Well Name: SAKER 6-7 FEDERAL
COM

Sundry ID: 2790866

Type of Action: APD Change

Procedure Description: Oxy USA Inc., respectfully requests approval to amend the subject well AAPD to change the SHL, TVD, BHL and amend the casing to our 3-string slim w/ T95 Production Casing design. See attached APD sundry change overview worksheet along with the updated well plat and drilling documents. Please note: The well pad did not change. It is renamed Falcon_T24SR35E_6_Pad 2. "THE SHL IS MOVING 230' TO THE EAST AND THERE IS NO ADDITIONAL SURFACE DISTURBANCE RELATED TO THIS SUNDRY"

WELL LOCATION AND ACREAGE DEDICATION PLAT

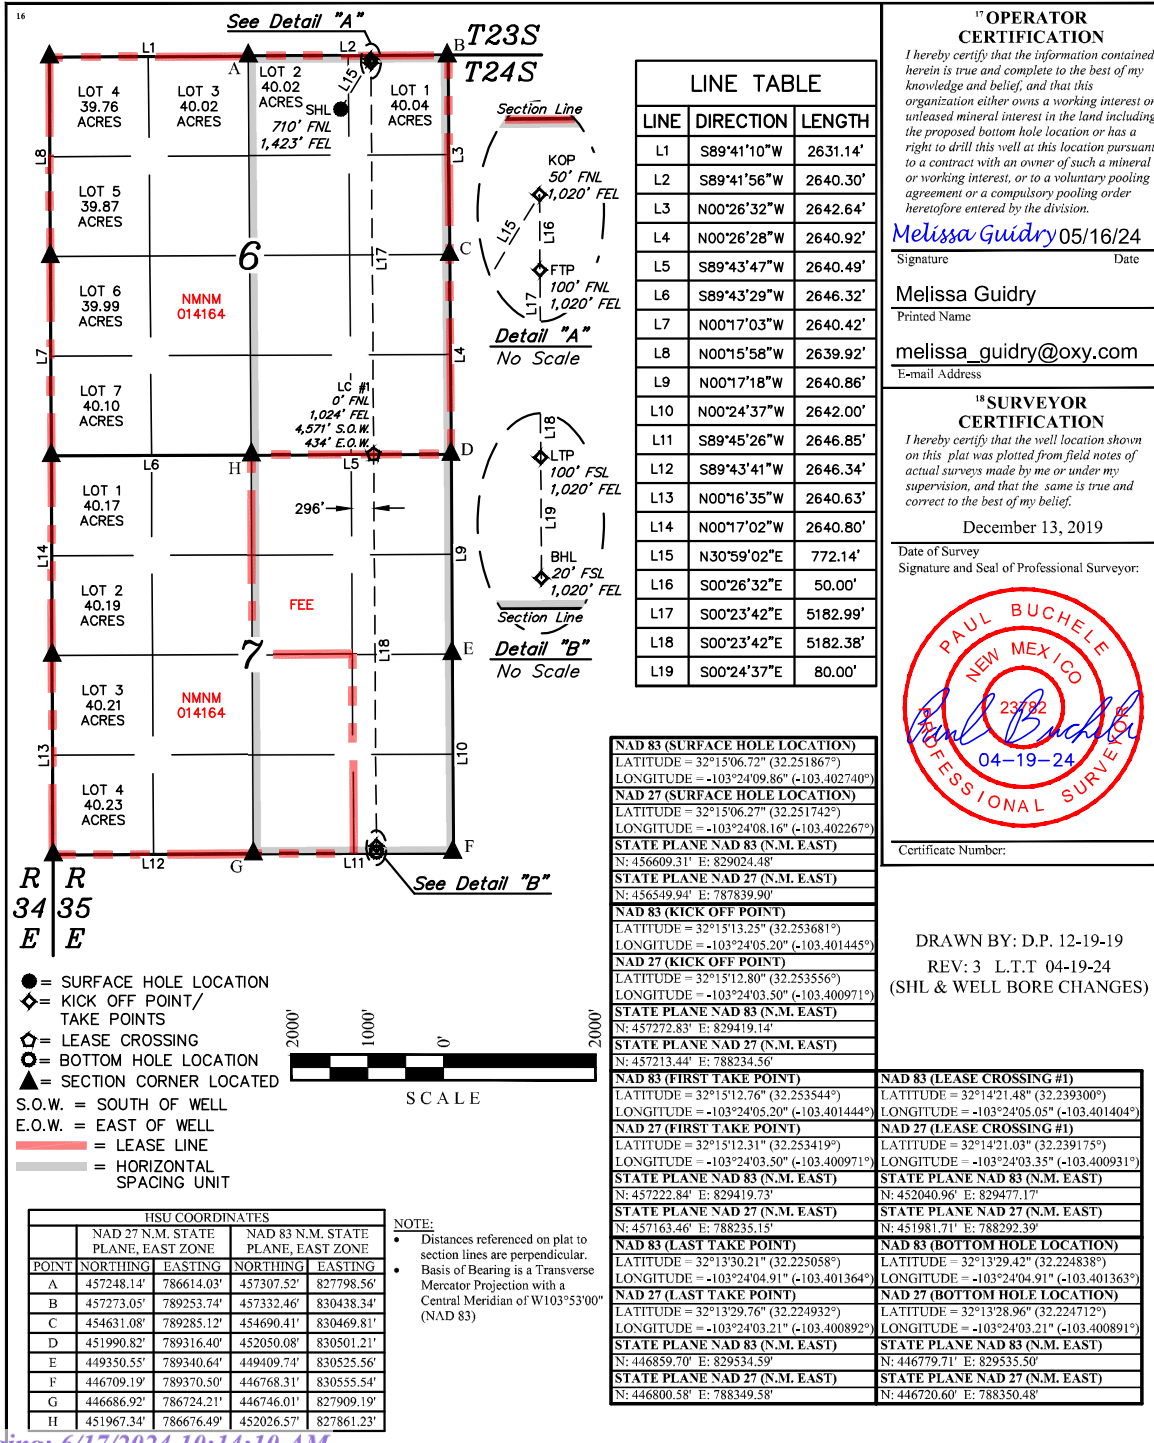
Oxy USA Inc., respectfully requests approval to amend the subject well AAPD to change the SHL, TVD, BHL and amend the casing to our 3-string slim w/ T95 Production Casing design. See attached APD sundry change overview worksheet along with the updated well plat and drilling documents.

"THE SHL IS MOVING 230' TO THE EAST AND THERE IS NO ADDITIONAL SURFACE DISTURBANCE RELATED TO THIS SUNDRY"

UL or lot no.	Section	Township	Range	Lot Idn	Feet from the	North/South line	Feet from the	East/West line	County
2	6	24S	35E		710	NORTH	1423	EAST	LEA

UL or lot no.	Section	Township	Range	Lot Idn	Feet from the	North/South line	Feet from the	East/West line	County
P	7	24S	35E		20	SOUTH	1020	EAST	LEA
¹² Dedicated Acres 640.06	¹³ Joint or Infill	¹⁴ Consolidation Code	¹⁵ Order No.

Wellhead diagram during skidding operations

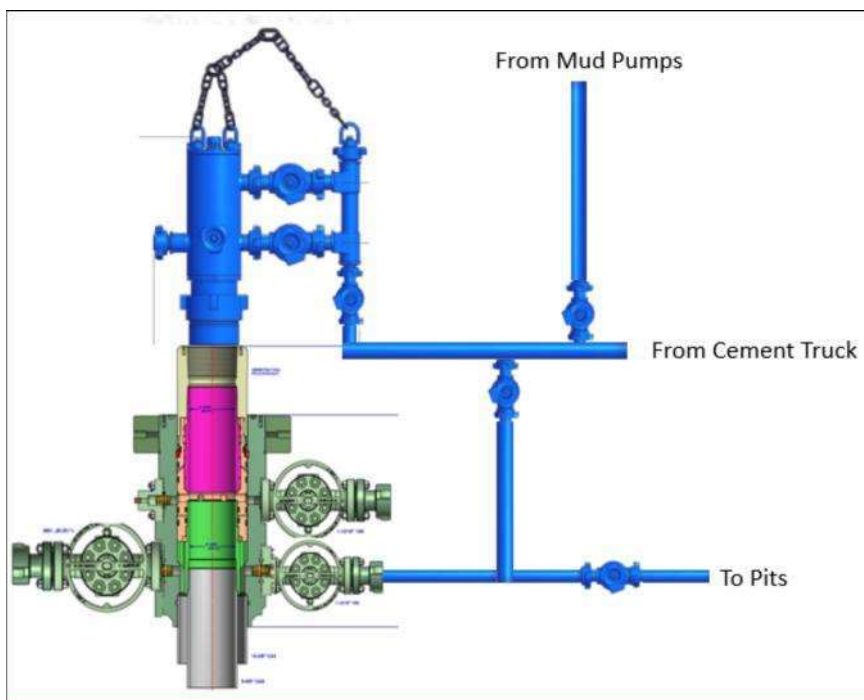
Oxy requests a variance to cement the 9.625" and/or 7.625" intermediate casing strings offline in accordance to the approved variance, EC Tran 461365.

5. After confirmation of both annular barriers and internal barriers, nipple down BOP and install cap flange.
 - a. If any barrier fails to test, the BOP stack will not be nipped down until after the cement job is completed with cement 500ft above the highest formation capable of flow with kill weight mud above or after it has achieved 50 psi compressive strength if cannot be verified.
